FIELD REVISION NO.02

CAMPING WORLD

AT THE OPPIDAN RETAIL CENTER

OPPIDAN INVESTMENT COMPANY

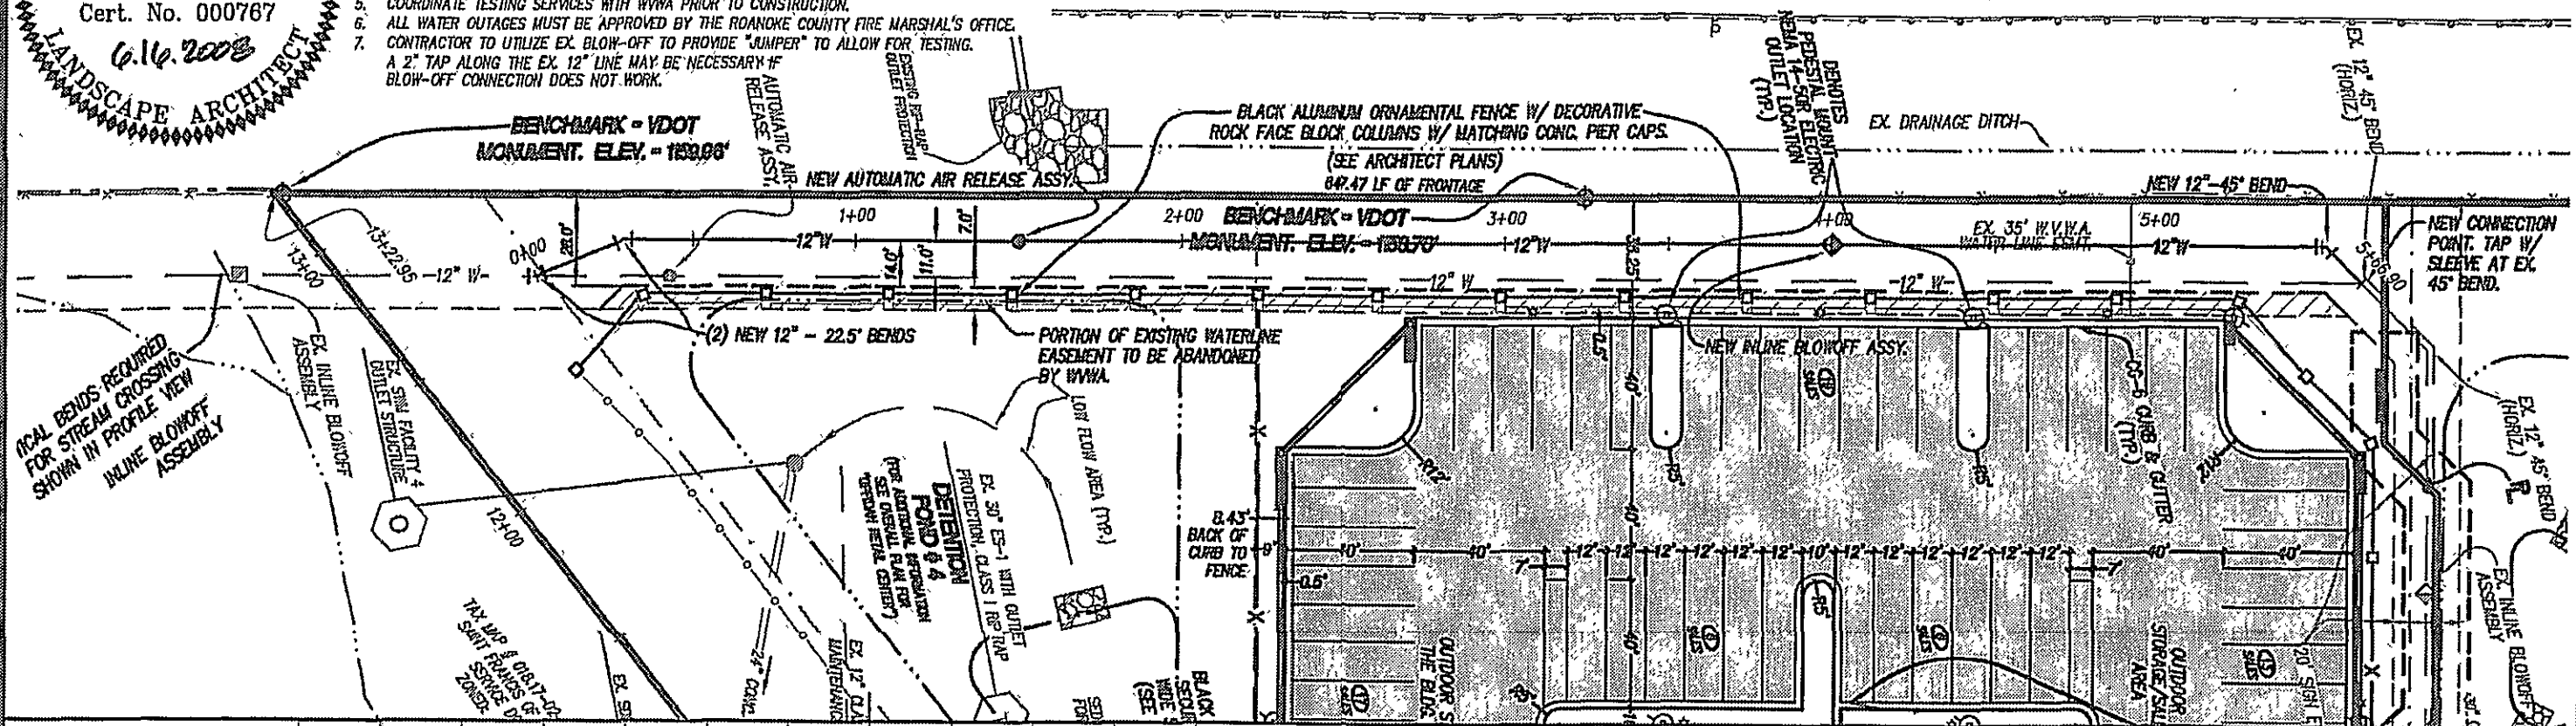
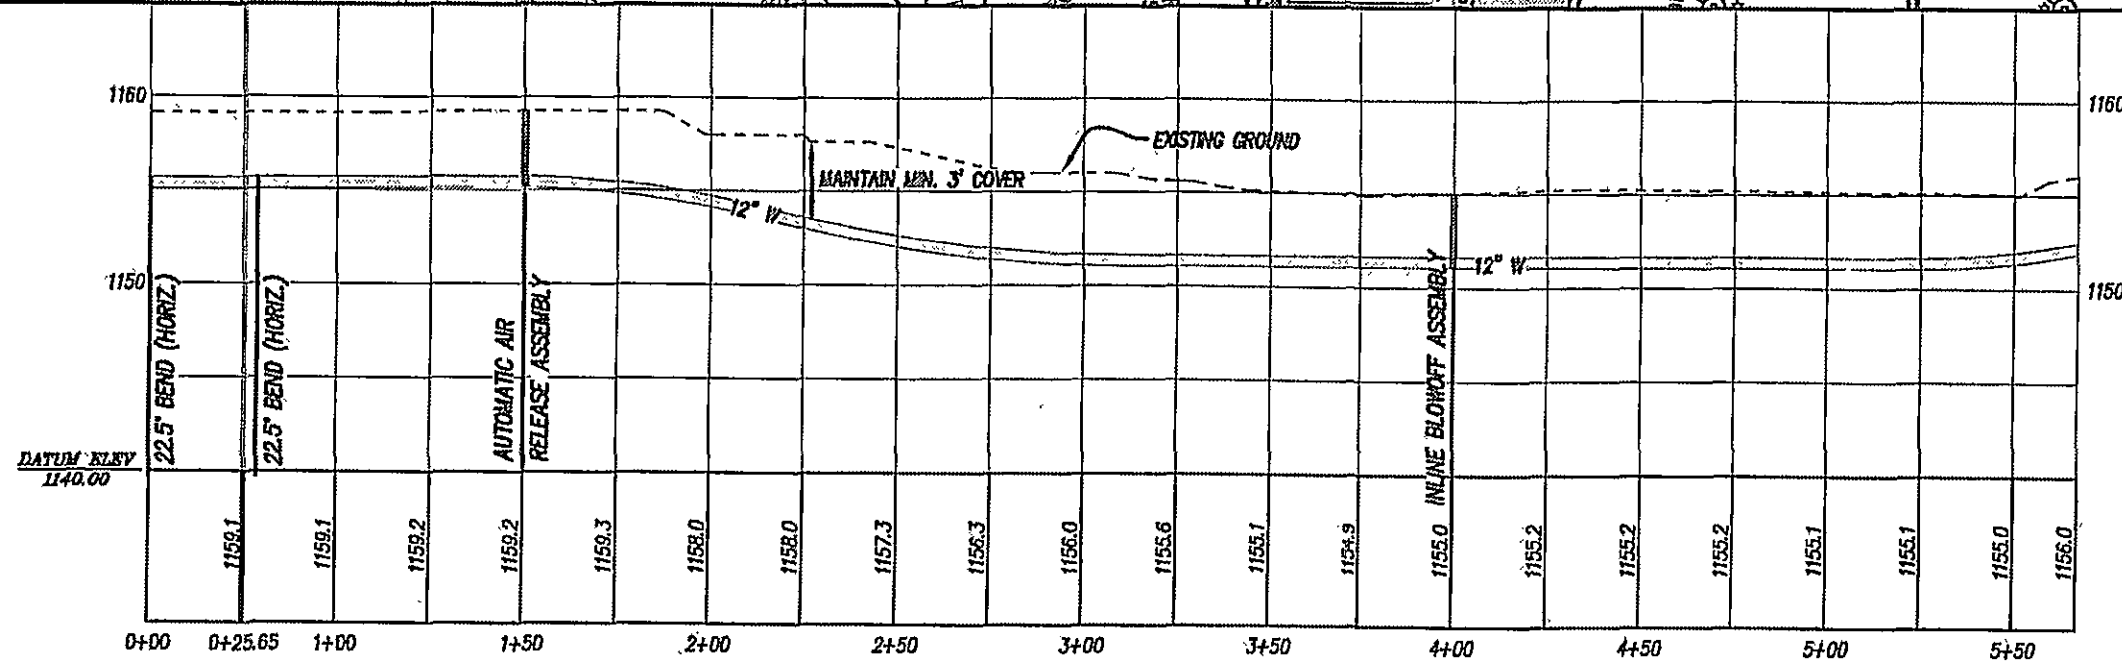
3. A MINIMUM OF ONE FULL JOINT OF THE EXISTING PIPE SHALL BE REMOVED AT EACH END OF THE PORTION OF PIPE TO BE ABANDONED IN PLACE, AND ALL TRACER WIRE ON THE EXISTING PIPE THAT IS EXPOSED DURING THE ABANDONMENT PROCESS IS TO BE REMOVED.

4. WHEN FOUR (4) HOUR WINDOW IS APPROVED BY ROANOKE COUNTY FIRE & RESCUE AND WVWA, SHUT OFF VALVES, AT CLOSEST LOCATION TO RELOCATION TO ISOLATE THIS SECTION OF WATERLINE, DRAIN EXISTING LINE AND INSTALL NEW CONNECTIONS AS SHOWN.

5. COORDINATE TESTING SERVICES WITH WVWA PRIOR TO CONSTRUCTION.
6. ALL WATER OUTAGES MUST BE APPROVED BY THE ROANOKE COUNTY FIRE MARSHAL'S OFFICE. CONTRACTOR TO UTILIZE EX. BLOW-OFF TO PROVIDE "JUMPER" TO ALLOW FOR TESTING.

7. A 2" TAP ALONG THE EX. 12" LINE MAY BE NECESSARY IF BLOW-OFF CONNECTION DOES NOT WORK.
